Access Compliance Report Public Rights-of-Way (Curb Ramps)

Main Street: ANTONIO_PKWY		Cross Street: COW_CAMP_RD		Location:	N
ADA ID: RPRK211123131207	Ramp Type: Type 4 - Parallel	Initial Pass/Fail: Fail	Overall Compliance: No	Severity Score:	30

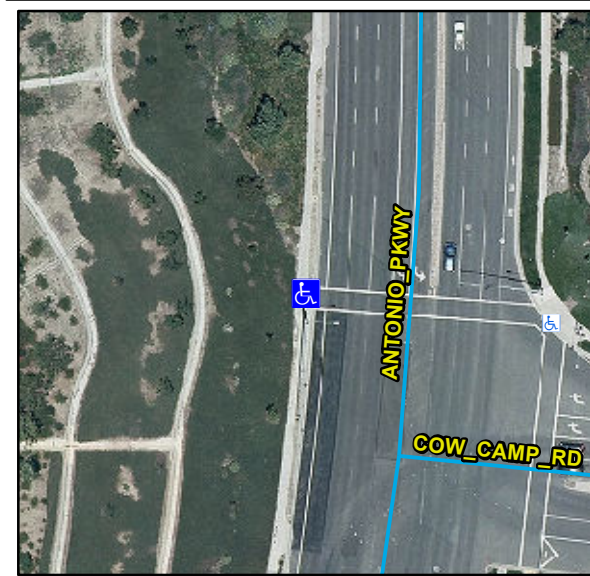
Compliance	Description	Data	Compliance	Description	Data
N/A	Ramp Length LT (in)	71	N/A	Ramp Length RT (in)	92
Yes	Ramp Width LT (in)	96	Yes	Ramp Width RT (in)	96
Yes	Ramp Run Slope LT (%)	4.7	No	Ramp Run Slope RT (%)	16.1
Yes	Ramp Cross Slope LT (%)	0.8	Yes	Ramp Cross Slope RT (%)	0.5
N/A	Landing Present	N/A	N/A	DWS Provided	N/A
N/A	Landing Length (in)	N/A	N/A	DWS Contrast	N/A
N/A	Landing Width (in)	N/A	N/A	DWS Length (in)	N/A
N/A	Landing Run Slope (%)	N/A	N/A	DWS Full Width	N/A
N/A	Landing Cross Slope (%)	N/A		DWS Offset Type	N/A
N/A	Landing Movement Obstructed?	N/A	N/A	DWS Offset Left (in)	N/A
	Landing Movement Type	N/A	N/A	DWS Offset Right (in)	N/A
N/A	Landing Shared	N/A			
N/A	Clear Space	N/A			
N/A	Clear Space To Crosswalk (in)	N/A			
N/A	Marked Crosswalk 1	Yes	N/A	Marked Crosswalk 2	N/A
	Crossing 1 Direction	E		Crossing 2 Direction	N/A
	Marked Crosswalk 1 Width (in)	144		Marked Crosswalk 2 Width (in)	N/A

N/A	Ramp Inside Crosswalk 1	Yes	N/A	Ramp Inside Crosswalk 2	N/A
	Crossing 1 Slope (%)	4.3		Crossing 2 Slope (%)	N/A
	Crossing 1 Cross Slope (%)	3.6		Crossing 2 Cross Slope (%)	N/A
N/A	Gutter Ponding	N/A	N/A	Curb Slope	8.3
Yes	Gutter Lip Height (in)	0		Road Run Slope (%)	N/A
N/A	Gutter Run Slope (%)	N/A		Road Cross Slope (%)	N/A
N/A	Gutter Cross Slope (%)	N/A	Yes	Perpendicular Joint Present	Yes
Yes	Overall Surface Condition	Acceptable			
	Cross Gutter Present?	No		Spandrel Present?	No
	Replace Cross Gutter?	N/A		Replace Spandrel?	N/A

Remove & Replace Entire Ramp.

R304.3.2, STD 1115
